PUBLIC HEARING MEMORANDUM

SUBJECT: **Petition #71-20**, petition for SPECIAL PERMIT/SITE PLAN APPROVAL to allow a 34-unit, a four-story structure up to 48' in height, multi-family dwelling greater than 20,000 sq. ft., to allow ground floor residential use, to allow an FAR of up to 2.0, a waiver of the minimum stall depth requirements, relief to allow 1.25 parking stalls per unit, and a waiver of the sustainable design standards at 1114 Beacon Street, Ward 6, Newton Highlands, on land known as Section 54 Block 22 Lot 04, containing approximately 51,745 sq. ft. of land in a district zoned BUSINESS USE 2. Ref: Sec. 7.3.3, 7.4, 4.4.1, 4.1.2.B.1, 4.1.2.B.3, 4.1.3, 7.8.2.C.2, 5.1.4.A, 5.1.13, 5.1.7.A, 5.1.8.B.2, 5.1.8.D.2, 5.4.2.B, 5.12 of the City of Newton Rev Zoning Ord, 2017.

1114 Beacon Street

Proposed Site Plan

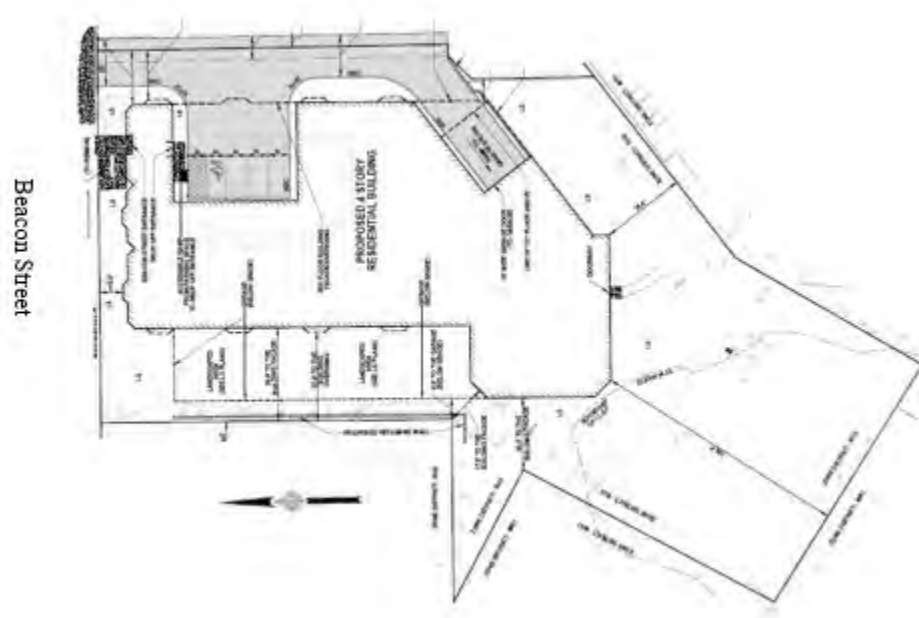
The site would be accessed by one curb cut from Beacon Street at the eastern property line, utilizing the existing easement shared with the adjacent property. The entrance to the underground garage is accessed via the drive aisle from Beacon Street and towards the rear of the building. The petitioner proposes to construct an as of right retaining wall along the southeastern and western property line. The retaining wall along the western property line reaches a maximum height of three feet at the midpoint of the site. Planning Staff notes the utility pole in front of the site along Beacon Street. The petitioner should clarify whether the utility pole will remain.
